Application Ref: NP/20/0407/FUL

Case Officer	Andrew Richards		
Applicant	Mr A Evans		
Agent	Mr R Hyde, Design by Hyde		
Proposal	Demolition of existing garage/workshop, and other extensions. Modernisation of existing building and new two storey extension to form a change in use to provide Key worker accommodation (C3 class) which comprises, 18 No. self-contained studio rooms. The proposal provides 9 No. parking spaces at the front and rear of the property with one being a disabled space. There is also provision for six cycle stands at the rear.		
Site Location	Coed-derw, St. Brides Hill, Saundersfoot, Pembrokeshire, SA69 9NP		
Grid Ref			
Date Valid	24-Aug-2020	Target Date	18-Oct-2020

Pembrokeshire Coast National Park Authority
Development Management Committee – 10th March 2021

PLANNING - Aerial Images and Context Plan
DRAWING NO. 1801-PL-11 / SCALE: 1:100 @ A2 / 29.01.21 / REV: /

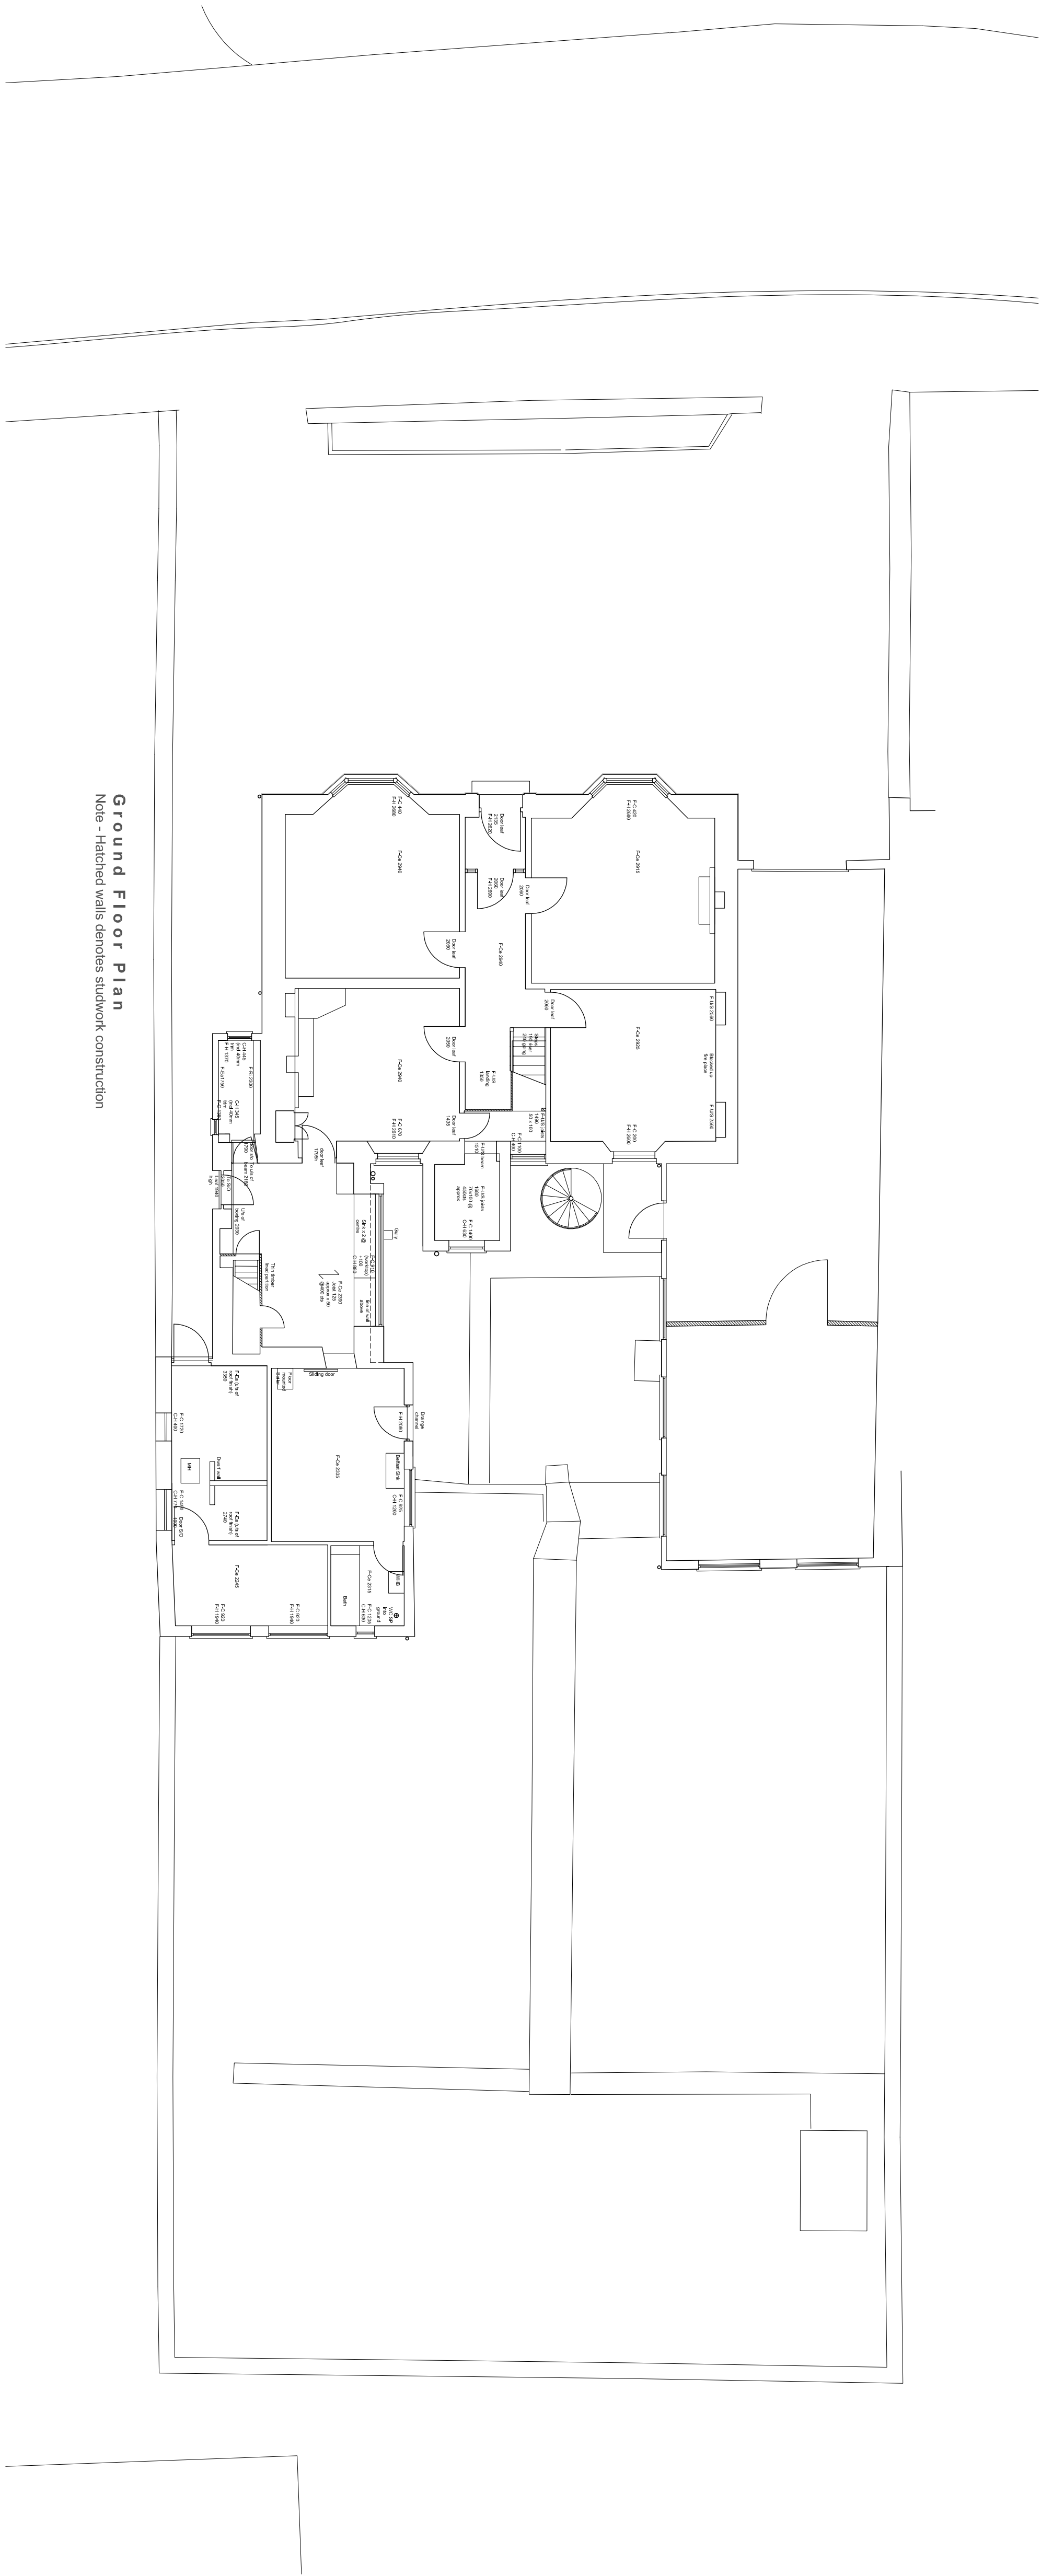
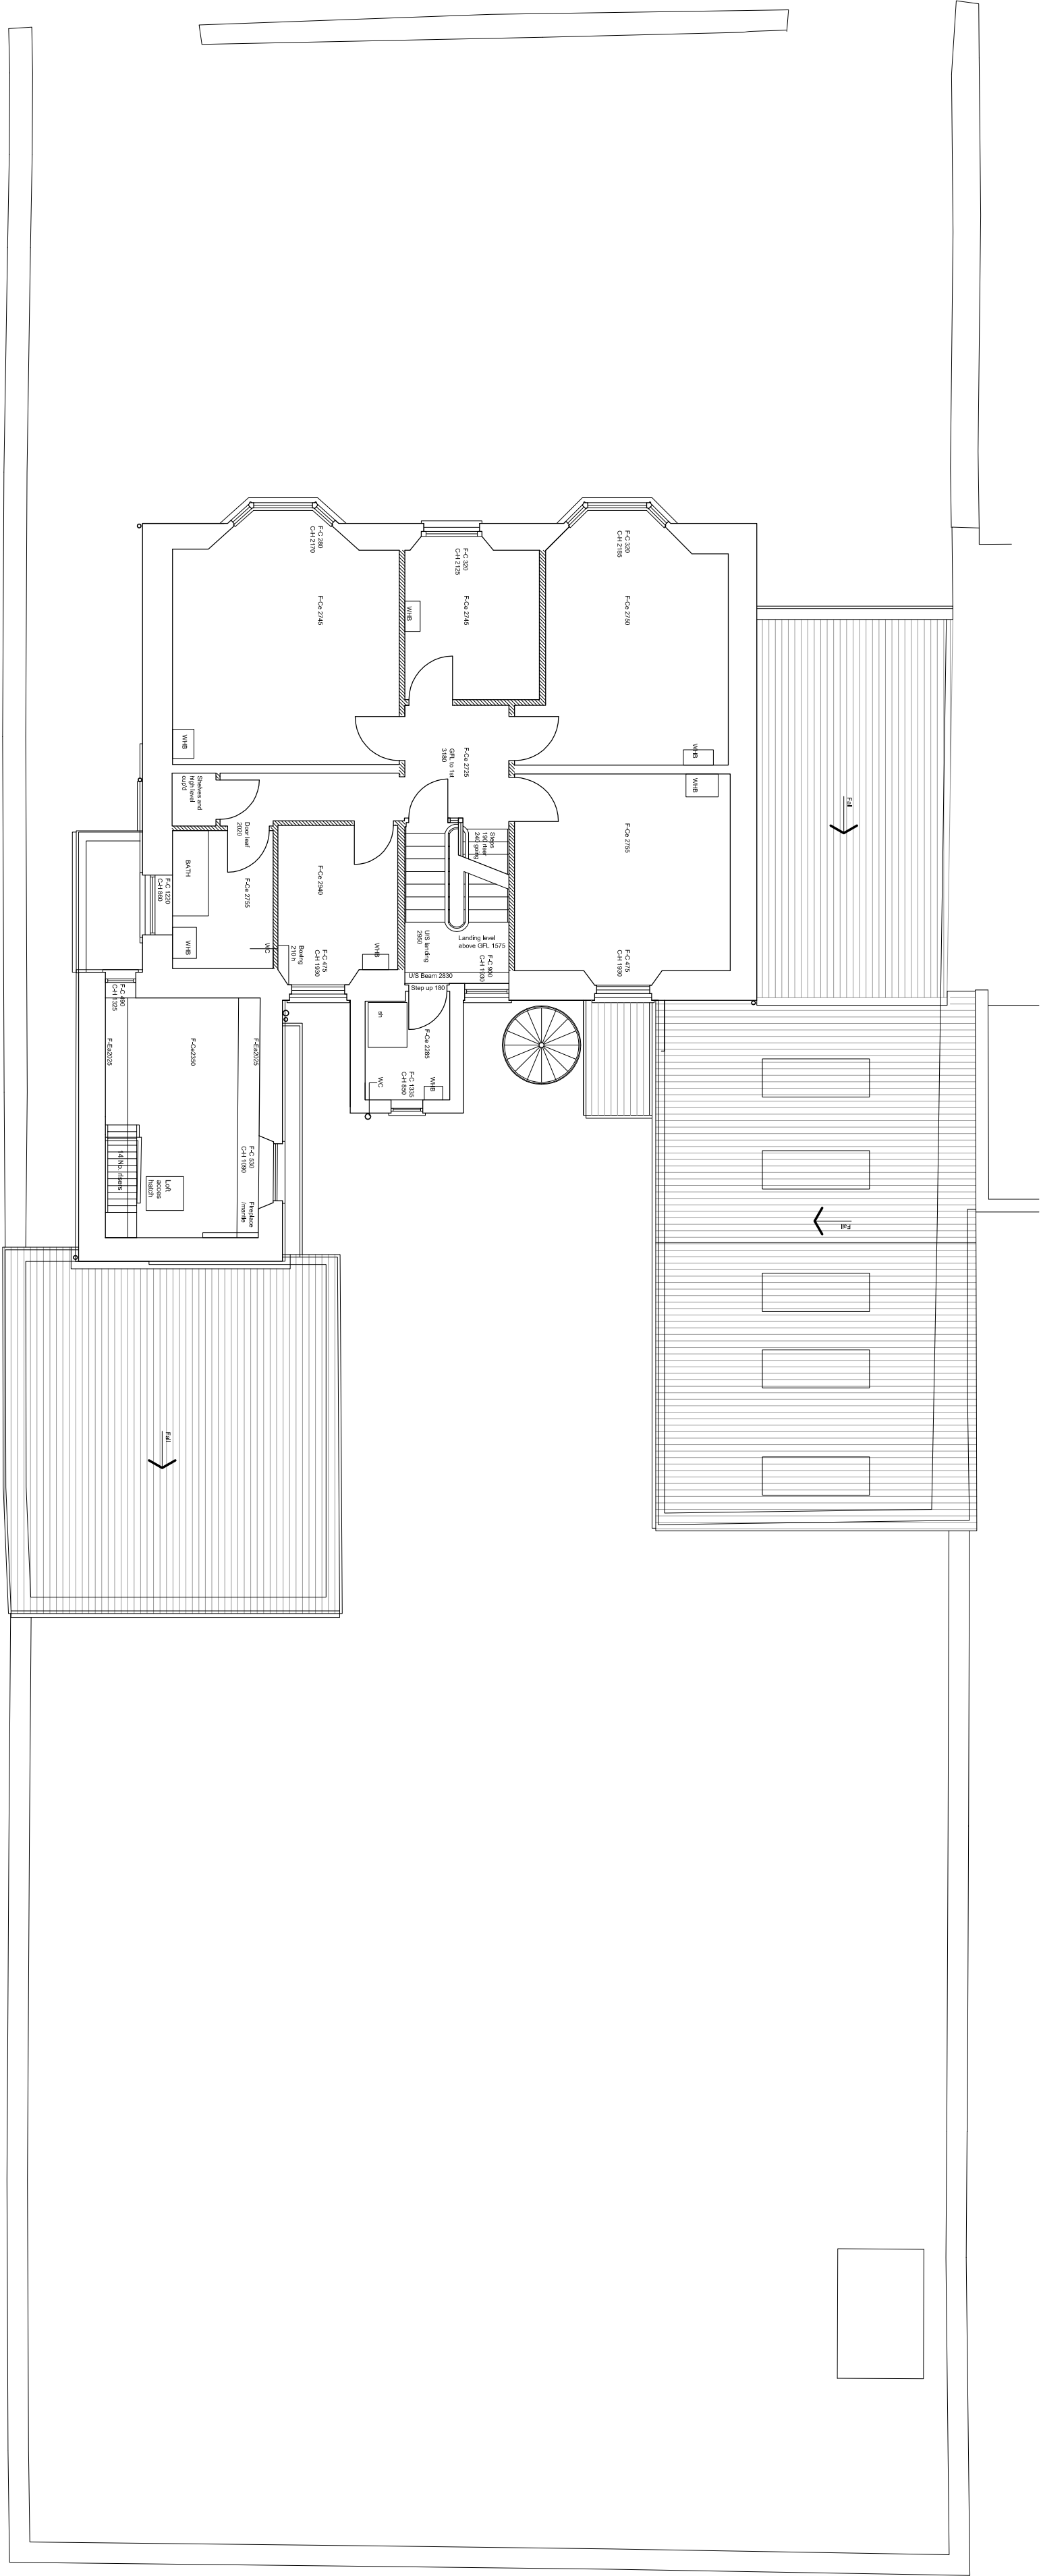
The current rear garden areas to Coed Derw and the adjacent residential properties mostly have an open aspect and the agent has submitted further correspondence in the form of an aerial image and context plan under drawing reference: 1801-PL-11. It is noted that several adjacent dwellings also have already had rear extensions and/or small external outbuilding structures within the rear gardens however these are not considered to be on a similar scale to the current proposed rear extension. As such, officers do not consider that a direct comparison can be drawn from the current proposal and the Claremont Hotel site or other smaller extensions within neighbouring gardens in this instance.
